Letter of Transmittal

Project reference: Former Chrysler Kenosha Engine Plant
 Groundwater Remediation
 WDNR FID 230004500
 BRRTS #02-30-000327

Response to Comment Letter Dated September 23, 2019

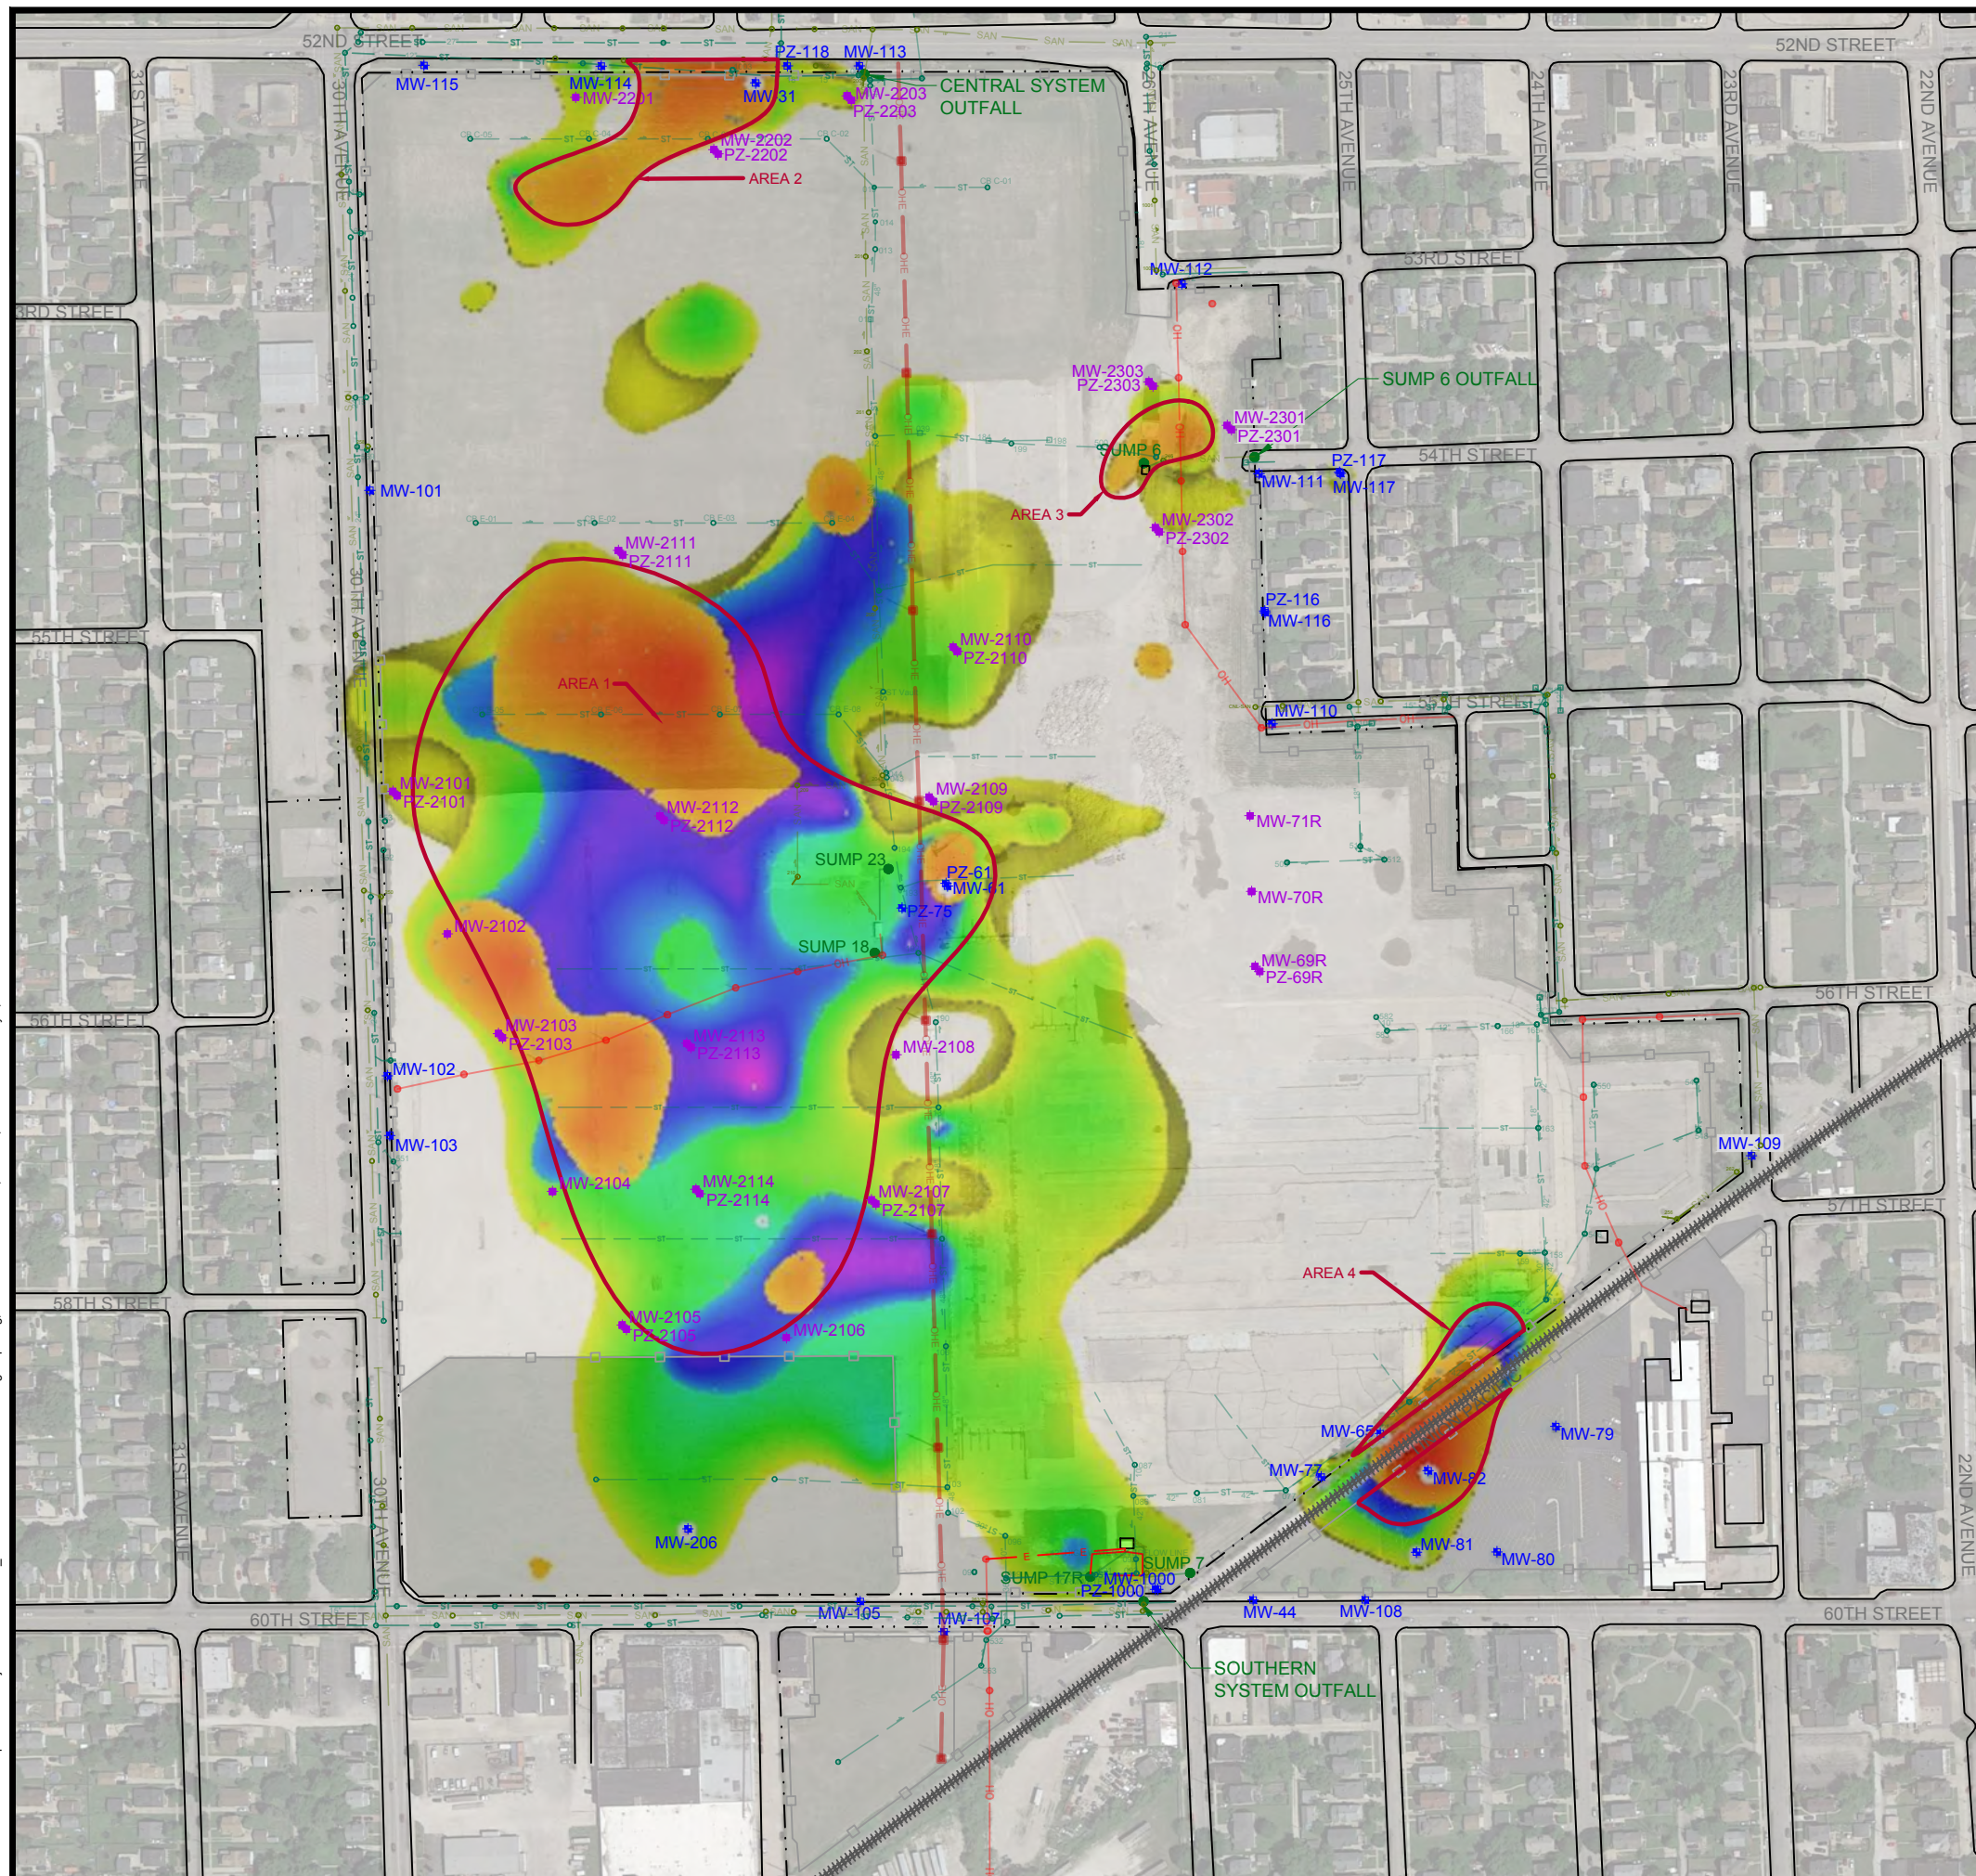
Comment

Yes, five areas of groundwater contamination are shown for the KEP in the 2015 Site Investigation Report. However, one of the five areas (MW-34A, MW-36A and MW-603) did not have CVOC exceedances over the enforcement standard. Further, the size and shape of the areas was further refined using a 3-D statistical approach using EVS as described in the response to Comment 2. The four zones for treatment are labeled and shown in Figure 10 included in the Groundwater Remedial Design Report.

The plume in Area 1 is ringed with proposed monitoring wells and piezometers and the distance between wells and/or well pairs ranges from 200 to 300 feet. Three additional well pairs are located within Area 1. Figure 10A has been added to the design report with the contaminant plume's interpolated groundwater concentrations removed, so that the proposed monitoring wells and the outlined treatment areas are clearly visible. When a proposed treatment plan is selected, both the well locations and density will be reviewed and modified if necessary.
